# Mamre Road Precinct DCP – Discussion Paper

Version 01 / March 2021

Document Control Sheet	
<b>Report Title</b>	Mamre Road Precinct DCP – Discussion Paper
<b>Version</b>	01
<b>Author(s)</b>	Prof Tony Wong and Prof Peter Breen
<b>Approved by</b>	Approver
<b>Signed</b>	
<b>Date</b>	5/03/2021
<b>Distribution</b>	Russell Hogan and Richard Seddon, MIRVAC Projects Pty Ltd

**Figure 1 extracted Figure 7-6 from Sydney Water Report2 – Source modelled flow frequency curves comparing baseline, and hypothetical BAU and Parkland approaches to Precinct-scale water management at Mamre Road Precinct.**

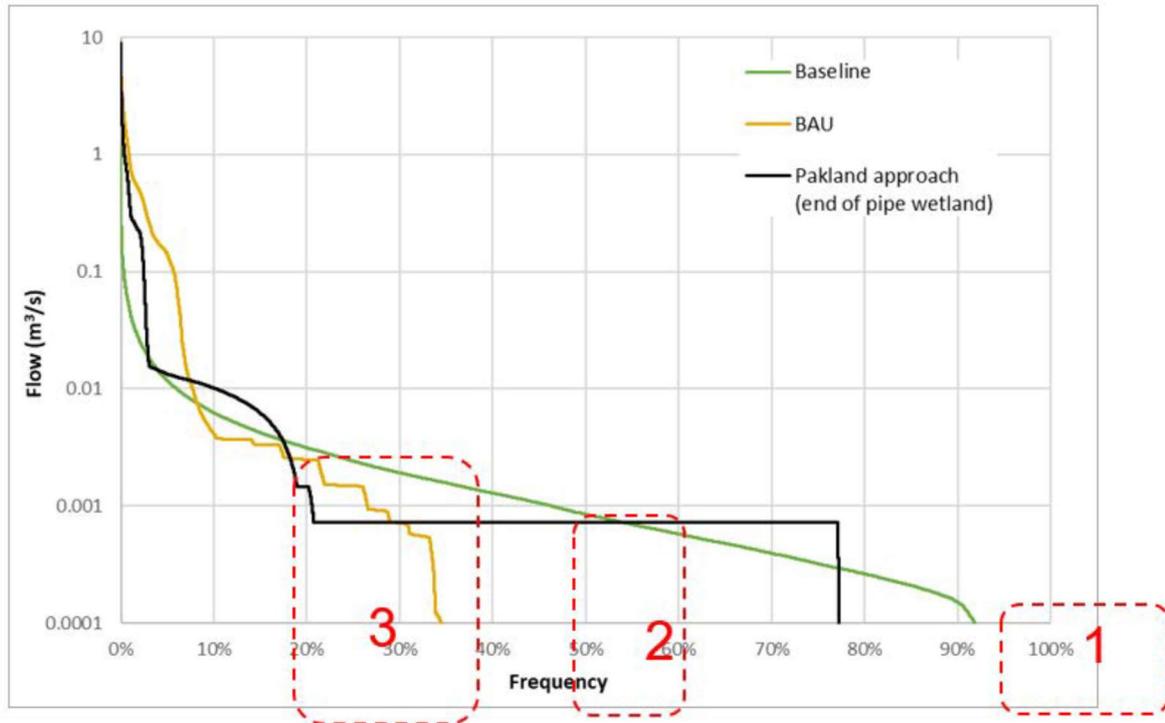
- the baseline flow characteristics depicted in Figure 1 are associated with a 3<sup>rd</sup> order or greater streams and it is assumed that the corresponding flow duration curves for the BAU and Parkland Approach are similarly for Precinct-scale solutions.
- The flow duration curve for the Parkland Approach has a curious shape with constant controlled flow rate of 0.0008 m<sup>3</sup>/s for flow frequency between 21% and 75%, which is abruptly terminated beyond the 75%tile.
- The Parkland Approach presented does not deliver a rigorous attempt at mimicking the flow duration curve, merely force fitting to key points representing the cease-to-flow, median flow and freshes in the baseline curves.

- d) As noted in the report, the near constant flow for such an extended period of the flow duration curve would require storage system (e.g. wetlands) with much longer detention period of over 3 times that of conventional approaches for best practice water quality outcomes.

The intent to mimic the baseline flow characteristics as outlined in Figure 1 and broadly in the table of ambient stream flow presented by DPIE is supported. However, the range of flow duration characteristics can be achieved in many ways, not all of which need to be related to the reduction of mean annual flow prescribed in the table, and the industry should be given the opportunity to develop such options based on particular site and development context.

Figure 2 – Plots of simple MUSIC results for the 54.37 Ha Aspect Industrial Estate site against 1<sup>st</sup> and 2<sup>nd</sup> Order Streams flow characteristics

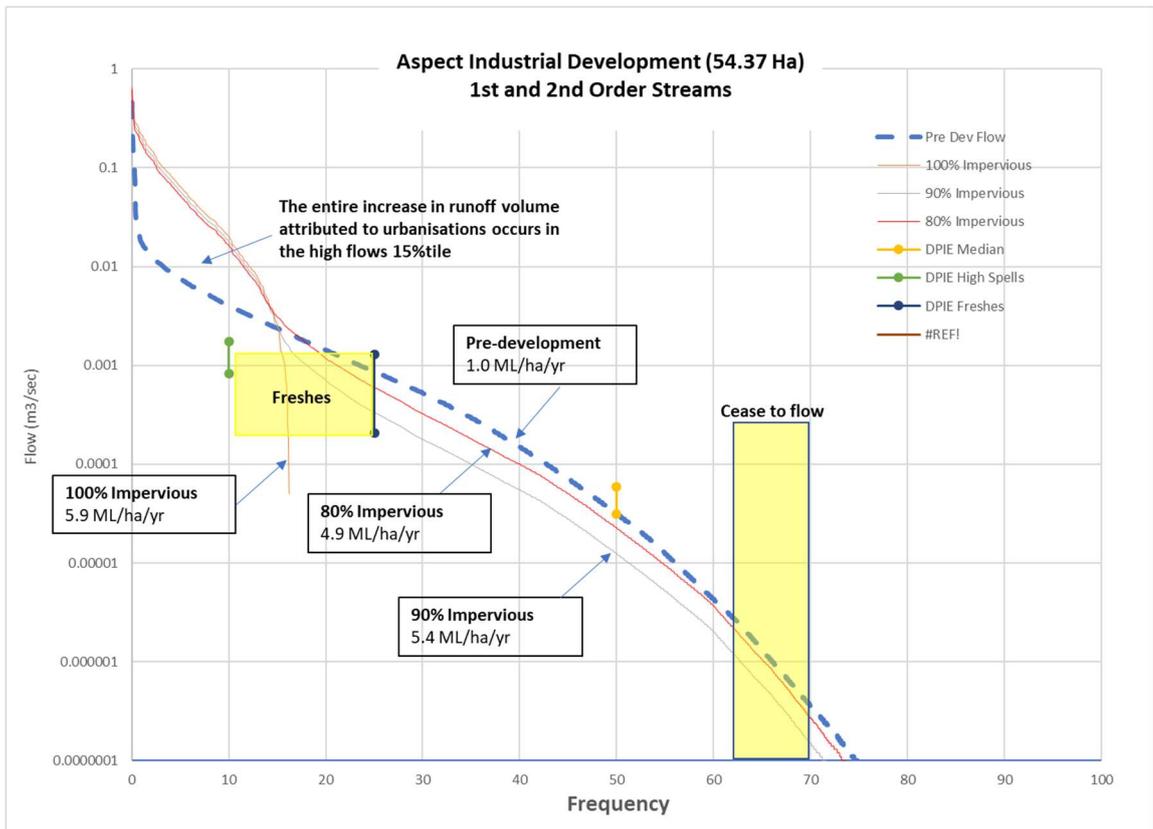
- a) The modelled baseline flow characteristics yield a MARV of approximately 1 ML/ha/yr, consistent with the prescribed MARV for 1<sup>st</sup> and 2<sup>nd</sup> order streams;

- b) The flow duration curve derived from MUSIC for the baseline conditions reproduced the cease-to-flow conditions, the median flow, the freshes, but has over-estimated the high spells; considering the suite of flow characteristics, the results of the MUSIC modelling is considered to have reasonably represented the pre-development conditions;

- c) The effect of urban development on flow characteristics is also shown in Figure 2, i.e.
  - (i) If the development consists of 100% impervious surfaces, the flow duration curve exhibits a cease to flow condition at the 16%tile, i.e. flow only occurs during periods of rain with no “hydrological memory” or lag in runoff and subsurface flows that are often associated with detention of water on undulating surfaces and in the soil;

- (ii) A small proportion of pervious area restores the low flow hydrology to some degree, especially the cease-to-flow conditions, as shown by the flow duration curves for development layouts consisting of 90% impervious surface and 80% impervious surfaces; note that the flow magnitudes are represented in log scale and the seemingly small departures from baseline conditions do represent substantial percentage reductions;

- (iii) Post-development conditions would result in a reduction in median flow and freshes and significant increases in the high spells;
  - (iv) The post-development scenarios report MARVs of 4.9 ML/ha/yr to 5.9 ML/ha/yr and all of the increases in flow volume occur during the period of rain as represented by the frequency of up to the 15%tile – it follows that, if mimicking the flow duration curve for protection of 1<sup>st</sup> and 2<sup>nd</sup> order stream is the principal management objective, a key flow management focus would be on mitigating the impact of development in the region between the 10%tile and the 15%tile;

Figure 3 – Plots of simple MUSIC results for the 54.37 Ha Aspect Industrial Estate site against 3<sup>rd</sup> order and greater stream flow characteristics

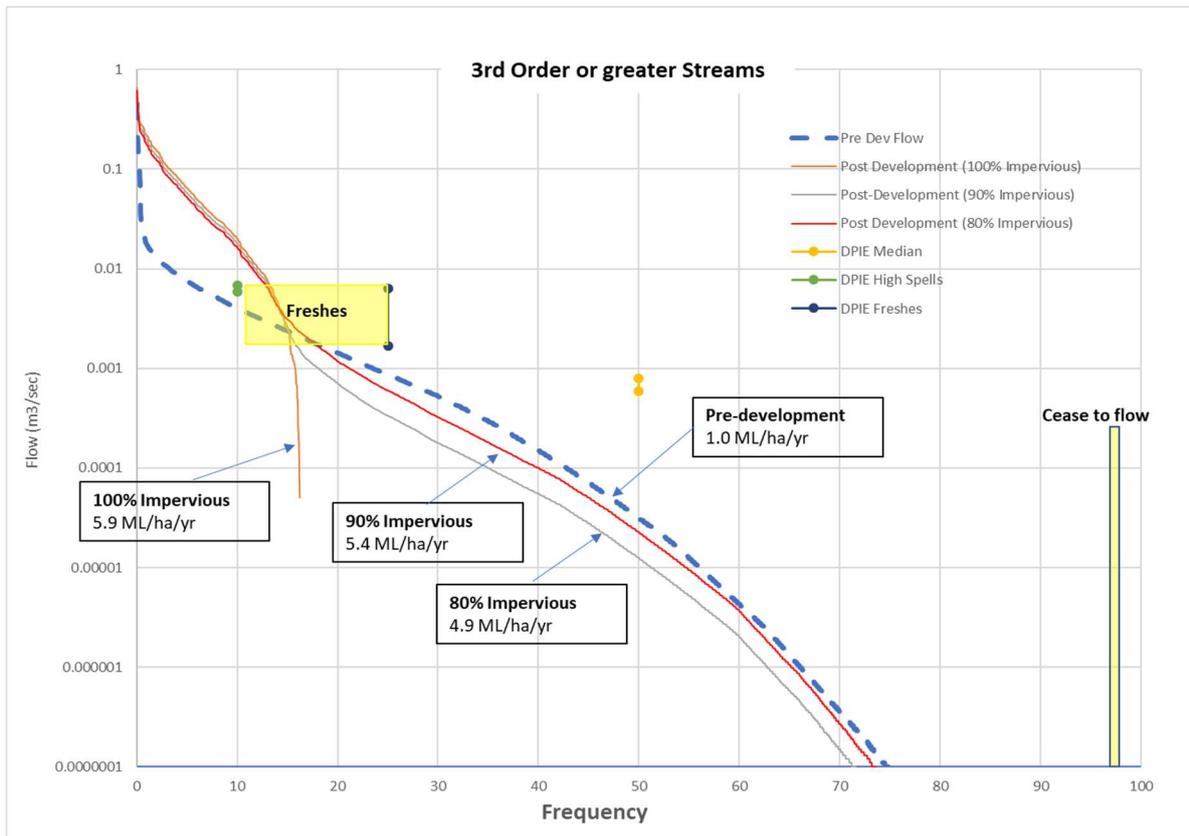
- d) Comparison of the modelled baseline flow duration curve against desired flow characteristics for 3<sup>rd</sup> order or greater streams are shown in Figure 3, which clearly show a significant departure from the stipulated median flow and cease-to-flow conditions while maintaining the “freshes” and modelled flow being closer to the high spells.

Figure 4 – Plots of simple MUSIC results for the 54.37 Ha Aspect Industrial Estate site with WSUD Initiatives against 1<sup>st</sup> and 2<sup>nd</sup> order stream flow characteristics

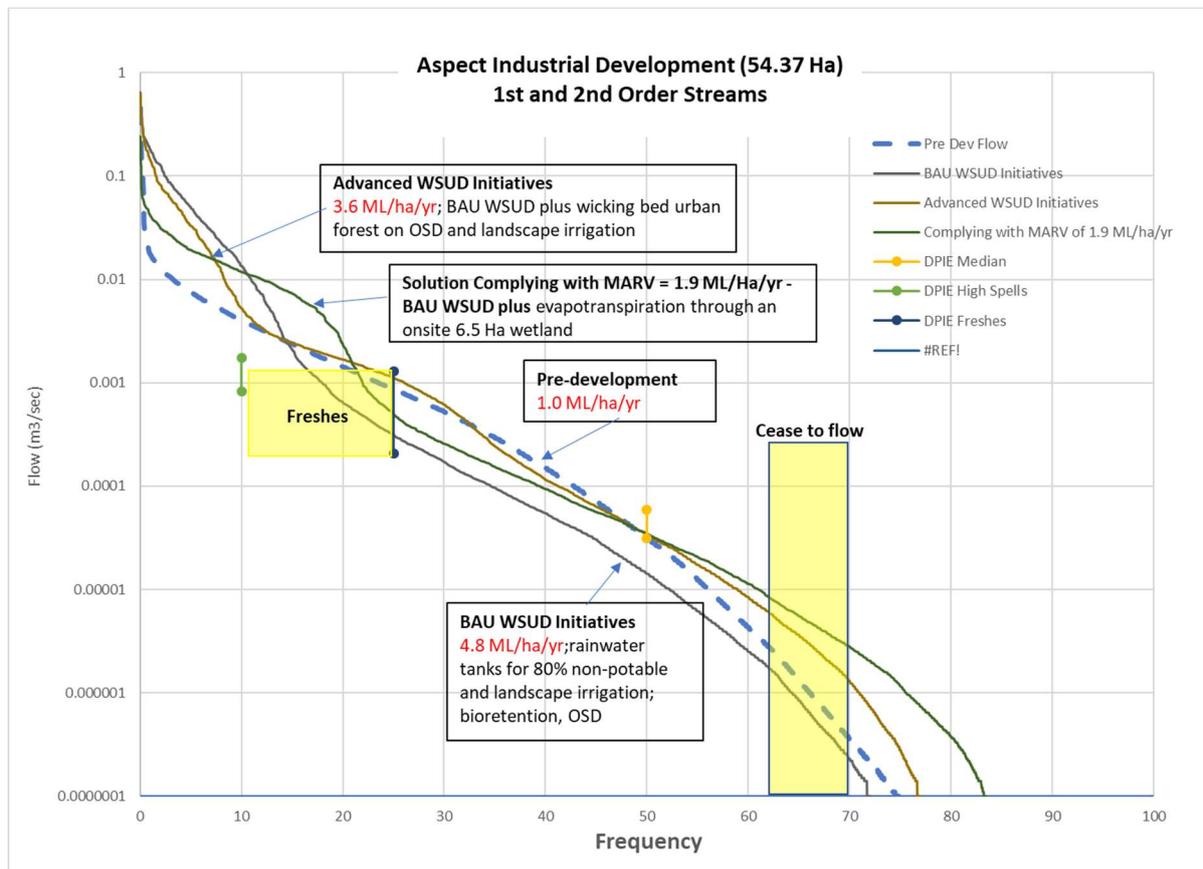
Figure 4 shows the results of introducing current WSUD measures that meets the Penrith 2014 DCP. The WSUD measures for current BAU development consist of rainwater tanks sized to meet 80% of the non-potable water demands, a bioretention basin to meet water quality pollutant load reduction, and an on-site 0.6Ha detention basin. Included in the development layout is the 4.5 Ha open space associated with the E2 Ecological Corridor, located inside the length of the northern property boundary.

- The resulting flow duration curve mimics the baseline curve very well from the 10%tile to the 50%tile.

- Further initiative may be required to reduce the SEI (currently 3.3) to between 1 and 2, through some further detention of peak storm discharges and external reuse of excess low flow. These initiatives would not significantly reduce the MARV but will better reproduce the baseline flow duration curve and reduce the stream erosion potential. Such initiatives could include high early discharge designs for the onsite detention basins.

Another analysis undertaken was to demonstrate the resulting flow duration curve for a solution that complies with the MARV of 1.9 ML/Ha/yr. This could only be achieved onsite through the construction of a 6.5Ha wetland serving largely as an evapotranspiration system with limited outflow. The resulting flow duration curve shown in Figure 4 is not considered to be an improvement to that for the “Advanced WSUD Initiatives” scenario without the associated increased land requirement.

The analysis reported herein demonstrate that mimicking the key flow characteristics of baseline conditions can be undertaken through a range of innovative WSUD initiatives which does not necessarily need to reduce the MARV to the extent stipulated.

Figure 5 – Comparing MUSIC results against 3<sup>rd</sup> order or greater stream flow characteristics

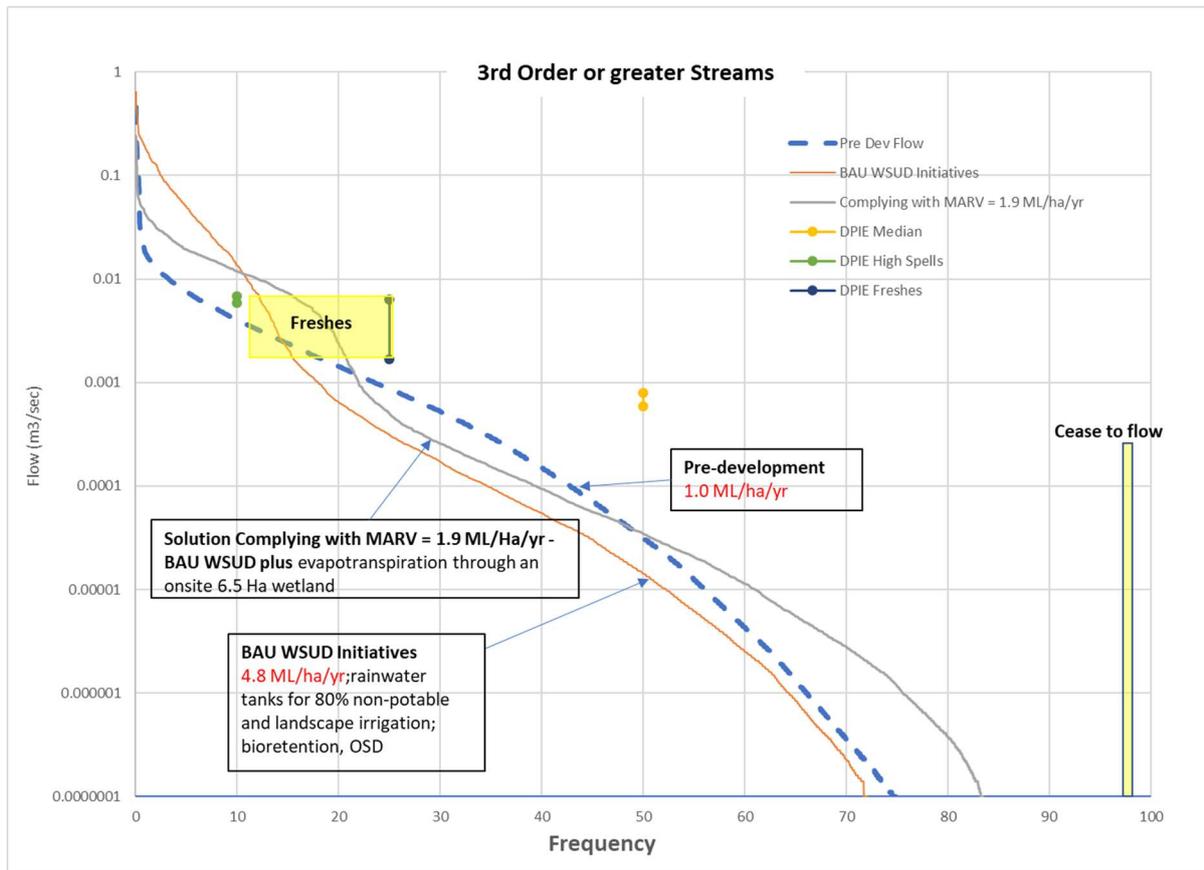
WSUD initiatives adopted that would comply with the 2014 Penrith DCP would not be able to mimic the flow characteristics of a 3<sup>rd</sup> order stream as shown in Figure 5.
